Lower Thames Crossing

Thurrock Council Comments on Traffic Modelling (D6A)

14 November 2023

Figure 3.2: Proposed lane marking modifications at Orsett Cock (Plate 3.6 of [REP6-058](#))

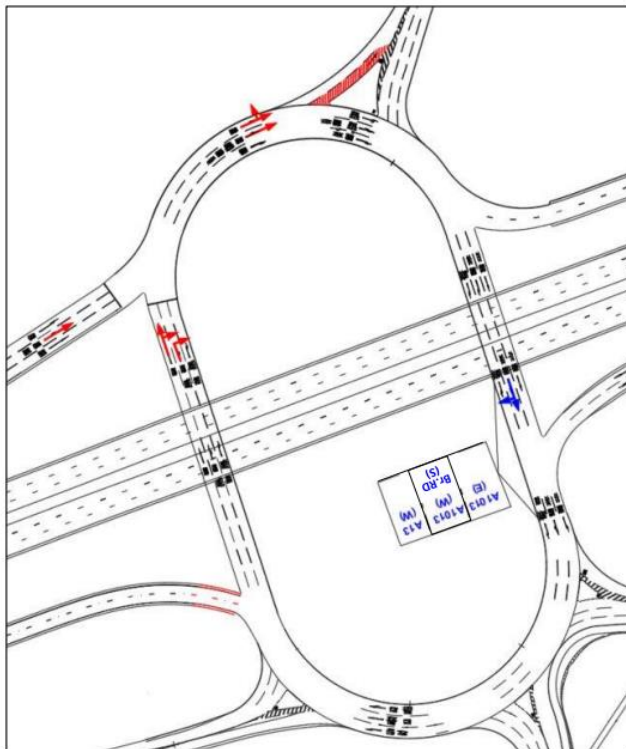
- 3.1.14 With regards to the revised lane marking, this was set out by the applicant in Plate 3.6 of the Orsett Cock VISSIM Forecasting Report ([REP6-058](#)) and has been reproduced below in **Figure 3.2**, but was not discussed with the Council before submitting v3.6, nor did it inform the Council it was making these changes.

Figure 3.3: Illustration of the lane allocation modelled in v3.6 of the forecast 'with LTC' VISSIM model

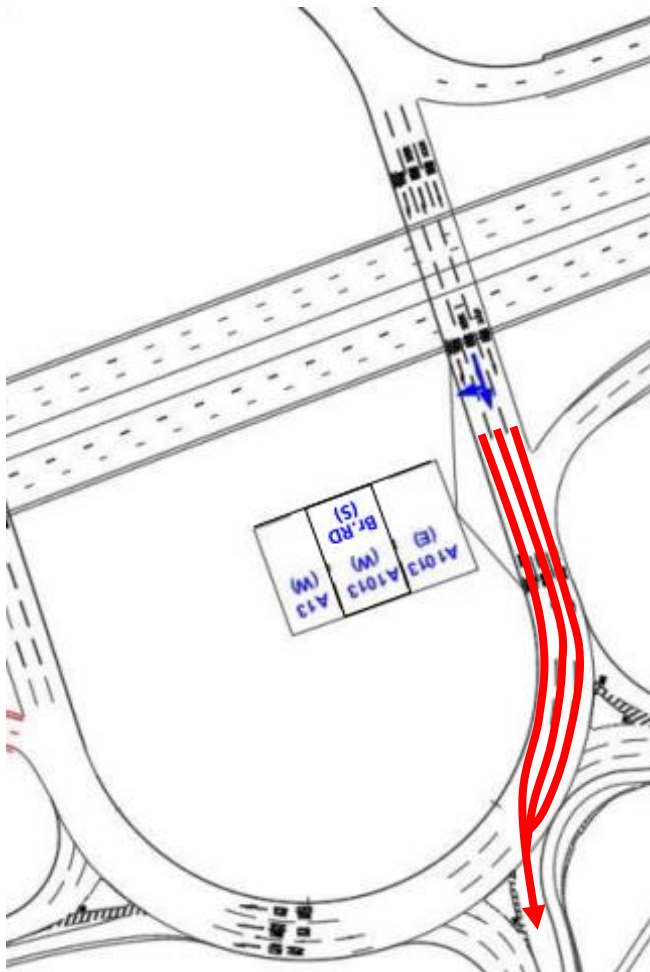
- 3.1.15 One of the changes made by the applicant in the 'with LTC' Do Something v3.6 model was to allow traffic to use the middle lane for the Brentwood Road (south) exit as well as the inside lane, with traffic needing to merge to a single lane to exit.
- 3.1.16 However, in the v3.6 'with LTC' model, all traffic on the circulatory was allowed to exit onto Brentwood Road (south) even from the outside lane. This would require traffic in three lanes to merge to a single lane on the circulatory carriageway to exit as illustrated in **Figure 3.3** below.

- 3.1.17 This is different to the arrangements presented in the Forecasting Report ([REP6-058](#)) and would likely be raised in a Road Safety Audit as a safety issue. This is because the proposed lane markings lead to conflicting vehicle movements, which would increase the chance of a collision. This is of concern to the Council as the Local Highway Authority for the junction and therefore responsible for ensuring the junction is designed and operates in a safe manner.

Figure 3.5: Comparison of LTAM and VISSIM v3.6T: Orsett Cock Junction – 2030 AM Peak Hour (0700-0800) – Delay per Vehicle (Seconds)

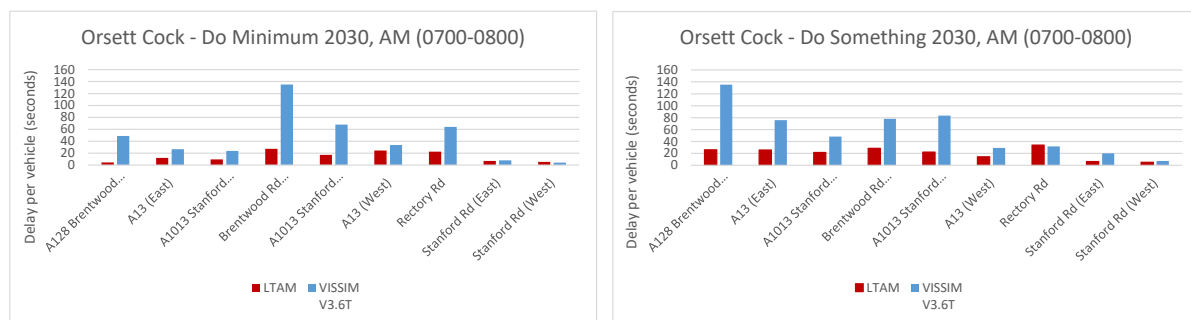
3.1.33 **Figures 3.5 and 3.6** below show this data graphically and clearly show the lack of alignment between the delays forecast by the two models.

Ref 3

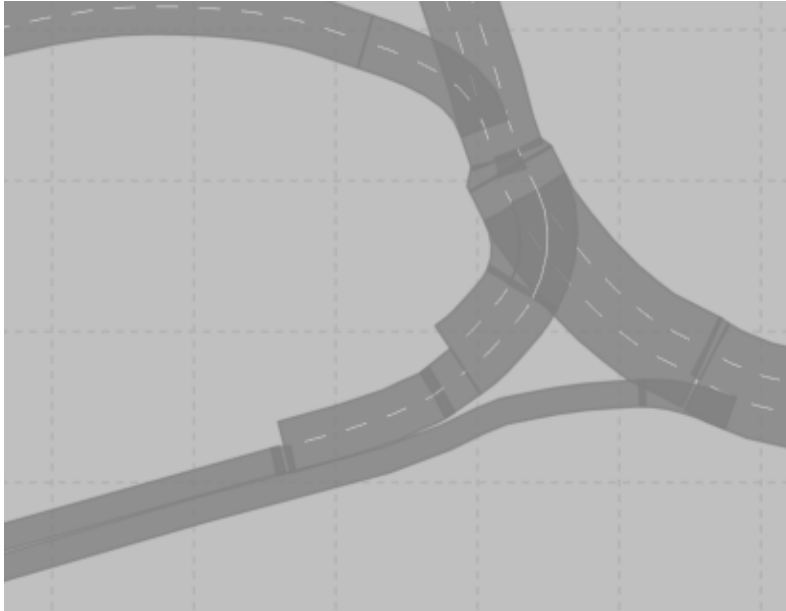
3	DM	Lane use in the circulatory carriageway	Lane allocation was updated on the main circulatory carriageway between the A13 eastbound off-slip and Brentwood Rd arm to reflect constructed lane allocation.		Ref3	Amber	At the time of model development, no as-built drawings were available. We agree to change this lane allocation in version 3 with southbound traffic to Brentwood Rd (S) using the left (nearside) lane, if we are provided with an 'as-built' drawing	NH has already been provided with the 'for construction' drawings. The as-built lane allocation for the southbound circulatory can also clearly be seen on aerial mapping. The Council has re-provided the 'for construction' drawings and has requested the 'as built' drawings', which will be provided when available. the Council accepts NH proposed resolution of this issue.	Green

Ref 4

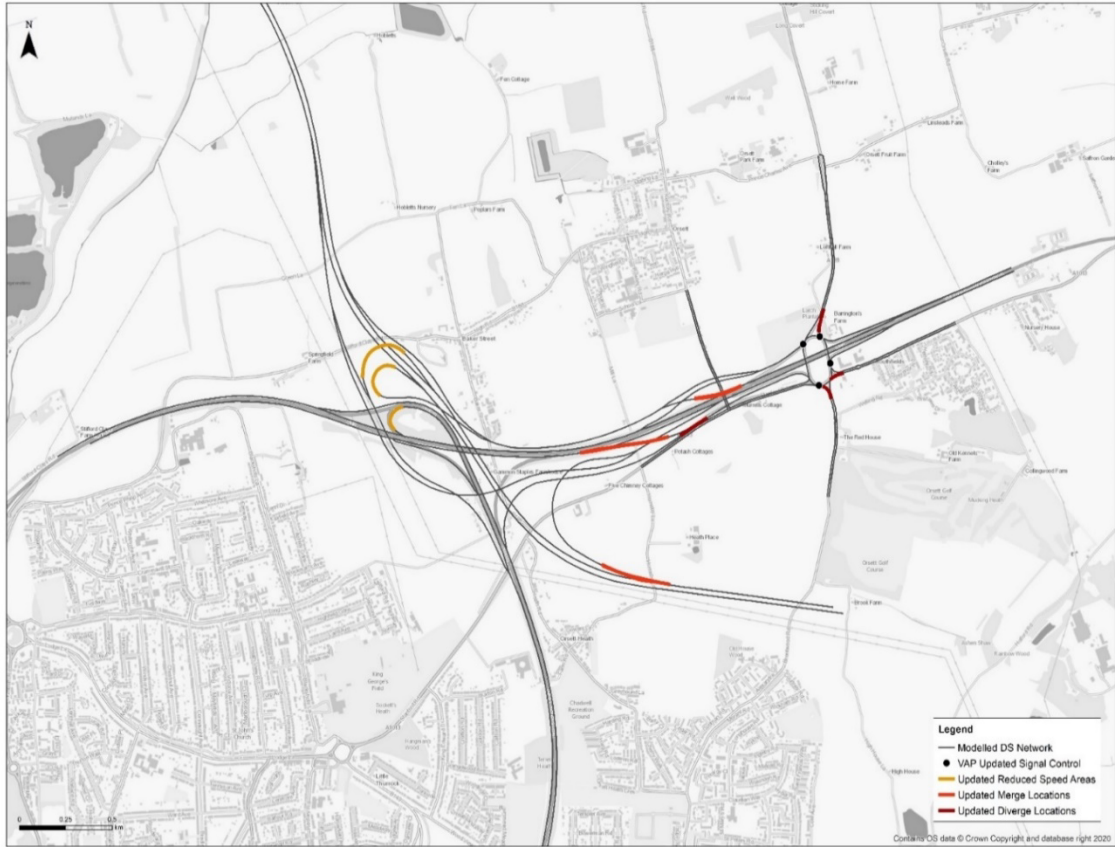
5	DS	Changes to merge locations	Changes to merge locations between the new LTC network and the A13 or the A13 and the LTC		Ref4	Red	<p>This is a difference in VISSIM coding style. The coding currently allows a merging behaviour for vehicles to merge in turn which is judged to be representative of driver behaviour in this area. NH do not agree with this change.</p>	<p>Thurrock Council considers that the applied VISSIM coding may underestimate throughput at the merges and may highlight issues with the model which would not happen when built. Despite differences from the recommended approach, National Highways' resolution is accepted.</p>	Green
6	DS	Changes to diverge locations	Changes to entry diverge locations within the model		Ref4	Red	<p>The slight difference in diverge locations is due to the coding style referred to above. NH do not agree with this change.</p>	<p>Thurrock Council considers that the applied VISSIM coding may underestimate throughput at the merges and may highlight issues with the model which would not happen when built. Despite differences from the recommended approach, National Highways' resolution is accepted.</p>	Green

Ref 15

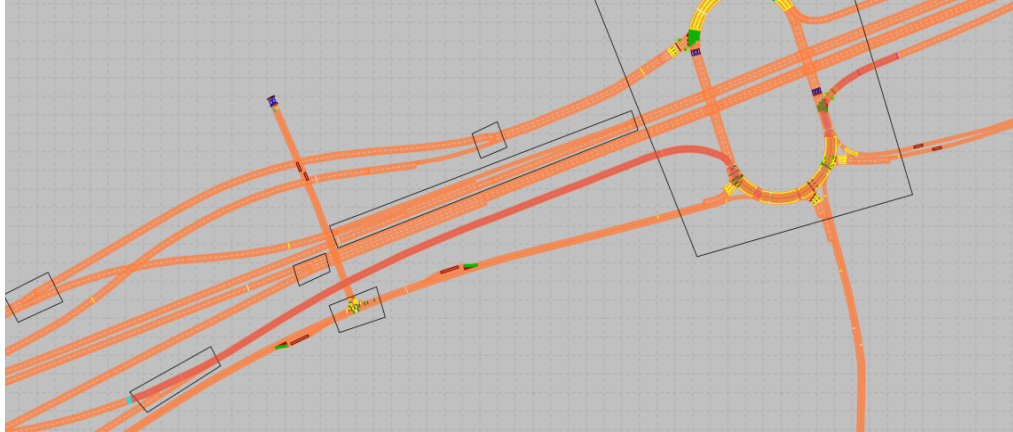
15	DS	Vehicle route closure	Vehicle route closure is added to prevent vehicles to use the A13 WB offslip - Orsett Cock - A12 EB onslip route		Ref15	Red	Already included in NH version 2 and will be included in version 3.	National Highways' resolution is accepted.	Green

Ref 18

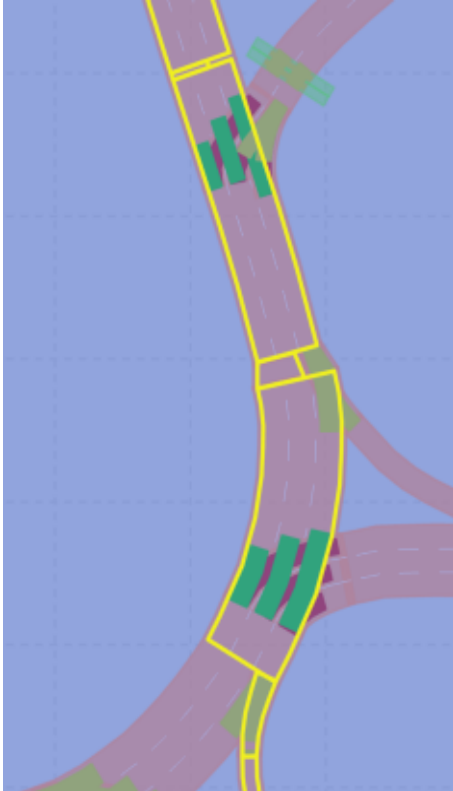
22	DM AM vs DM PM Priority rules		<p>Parameters between the DM AM and DM PM models has been changed for a number of priority rules, making the PM model more conservative. As these priority rules are removed for the DS model because of the signalisation of the junction, it makes the DM PM model much worse, and masks the delay differences between the DM and DS models.</p> <p>The parameters for the priority rules should be the same for the DM models as for the Base Year model, and should not be different between the AM and PM models. This change is not accepted.</p>	Red
23	DS	Pegasus crossing	<p>As requested by Thurrock Council, National Highways included a design of the pedestrian crossing in the DS models. Due to a software error in VISSIM 2020 version, the parametering of signal control behaviour not just reducing the safety distance of the vehicles around the signal stopline, but also reduces the gap acceptance times at priority rules, making vehicles to accept much lower gaps in traffic. This behaviour is unrealistically overestimating the capacity of Rectory Road priority junction.</p> <p>We suggest the application of a modified driving behaviour at the vicinity of the pegasus crossing, where the 'Reduced safety distance close to stop line' parameters are updated to have neutral impact on nearby priority markers.</p>	Red

Figure C2.1: A13 off slip and LTC weaving section

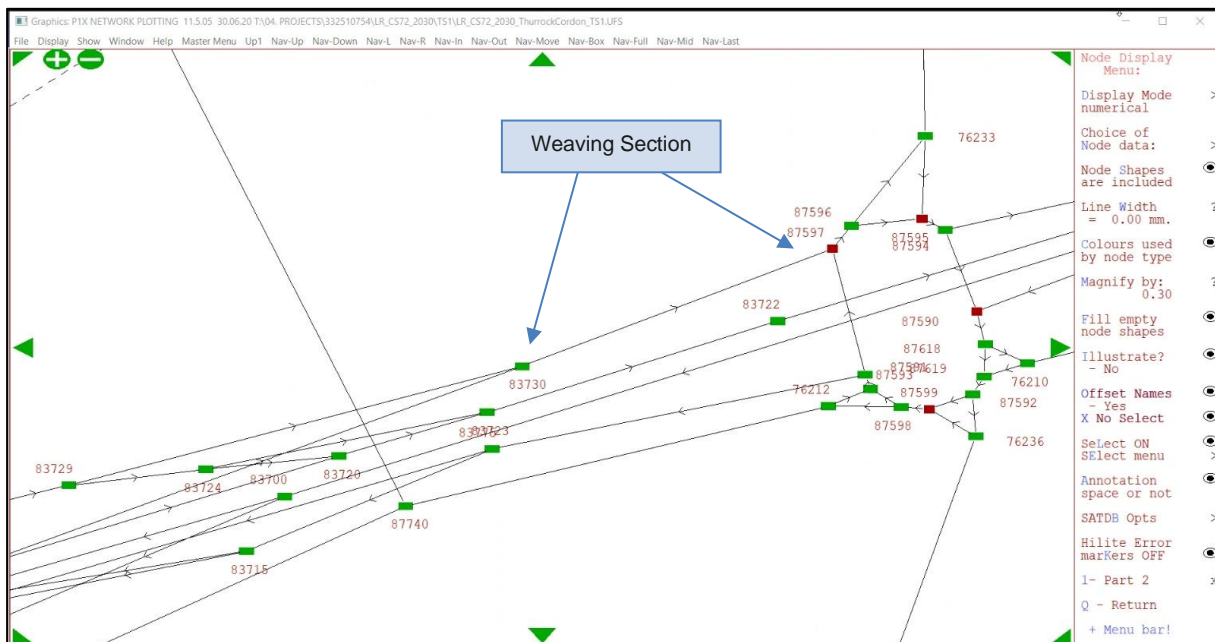
short section, which is not sufficient for the level of weaving traffic. The location of the weaving section of the highway network is presented in **Figure C2.1**, and it is the section between node 83730 and node 87597.

C.2.14 In LTAM, this section has a distance of 334 metres, which is longer than the distance assumed in the LTC drawings (90m) or in VISSIM (220m). The use of a distance of 334m further adds to the additional capacity at the junction and potentially results in an underestimation of queues and delays.
